**Seismic Re-Engineering of the Valdez Marine Terminal (VMT)  
Contract #556.08.01**

**The Prince William Sound  
Regional Citizen's Advisory Council  
(PWSRCAC)**

**Terry R. West, Ph.D., P.E.**

**December 2008**

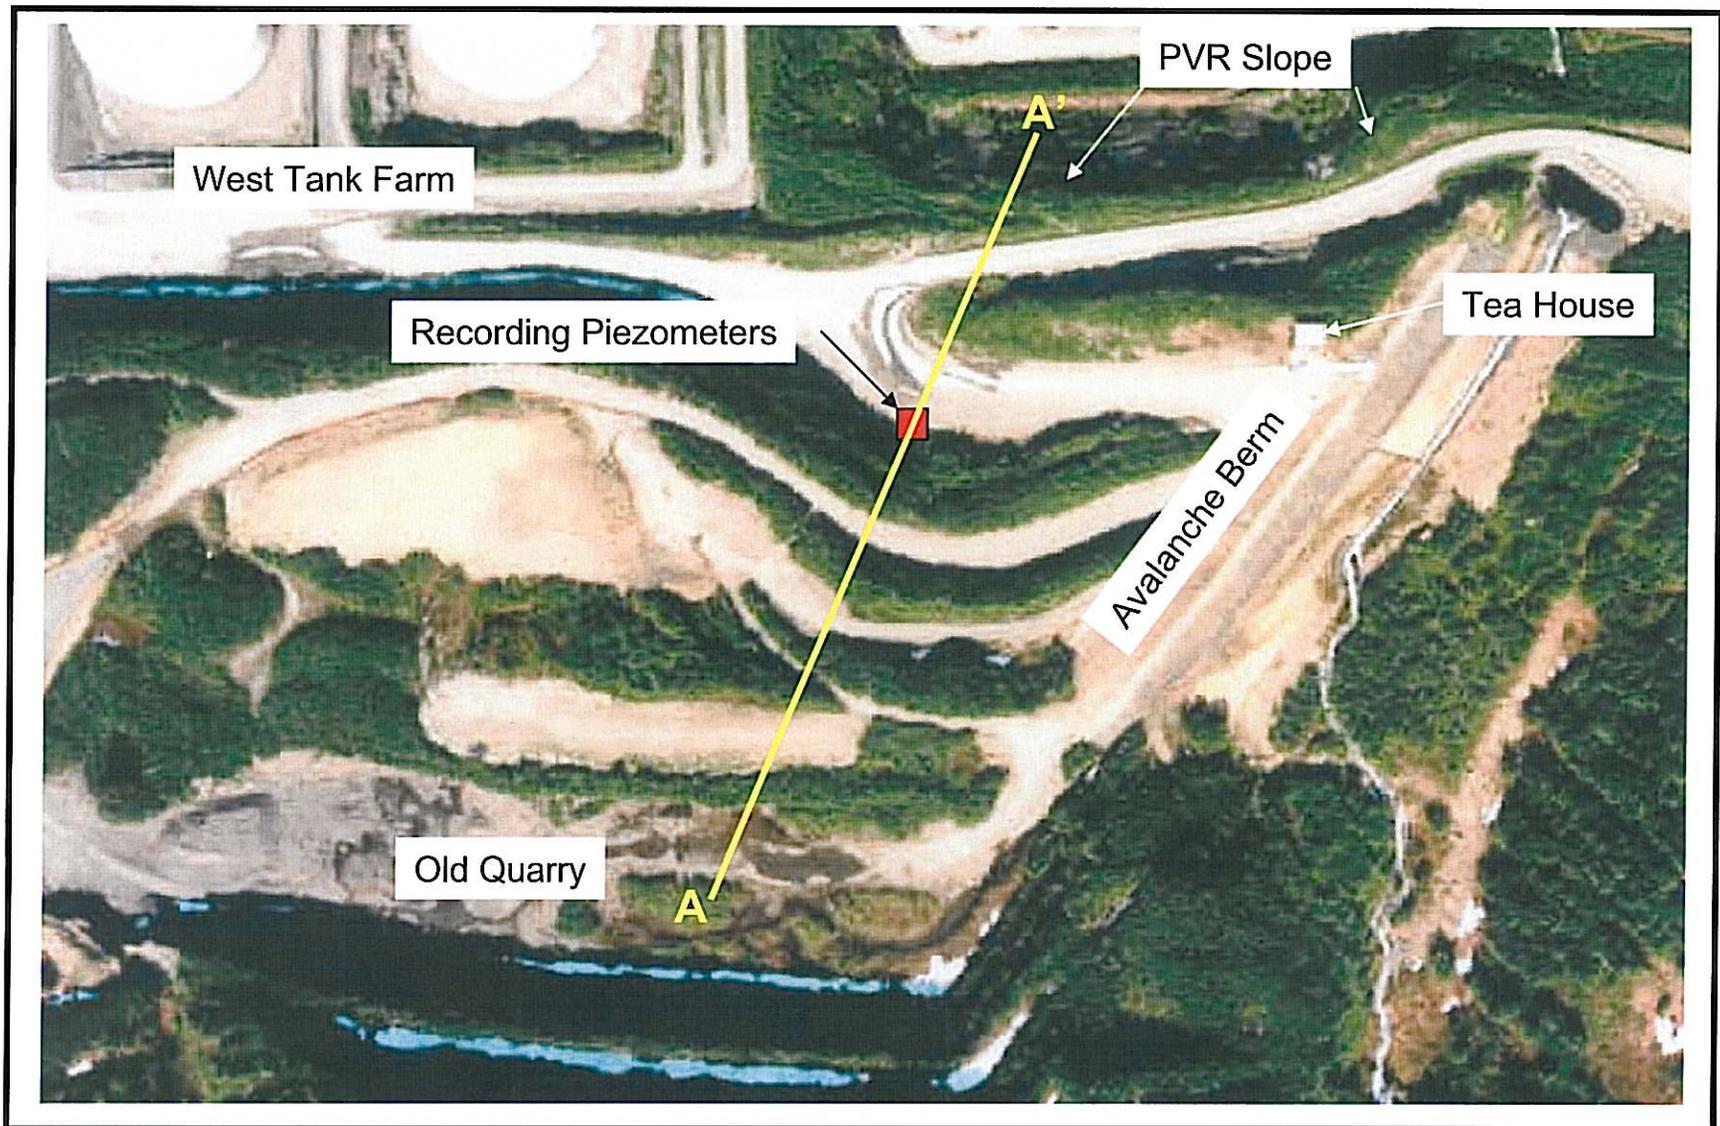
For the West Manifold area, a notch in the buttress allows water to flow out near a tank facility. Sediment marks well up on the structure were observed. Conclusion by the field party, this notch should be filled in to prevent continuing runoff from the bench area above.

Figure 1

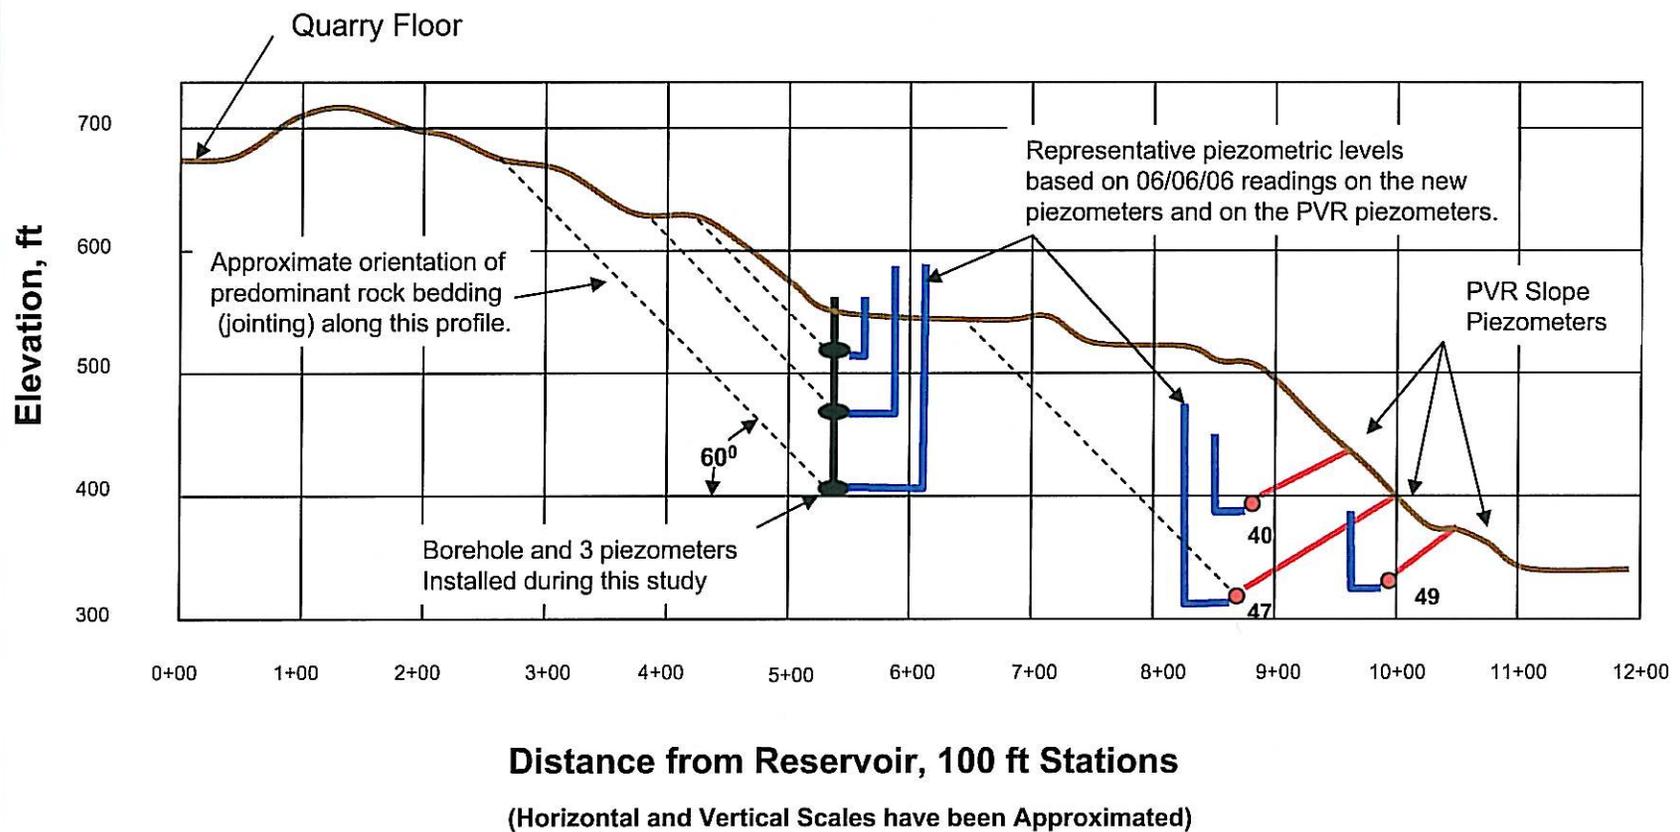
Data on the piezometers at the proposed dam site were provided to Dr. West following the July 2008 meeting with Alyeska at the VMT. These three figures are provided in this report in Appendix C. Figure 3 shows a fluctuation from 6 to 8 feet between October 2004 until October 2006 or a period of two years. The shallowest piezometer showed a variation of almost 5 feet and the deeper two piezometers showed a variation of between 6 and 7.5 feet. This is important information because the piezometers in the PVR slope are read only once or twice per year and annual fluctuation is not represented. This suggests that the annual fluctuation in the PVR piezometers could be as much as 5 feet.
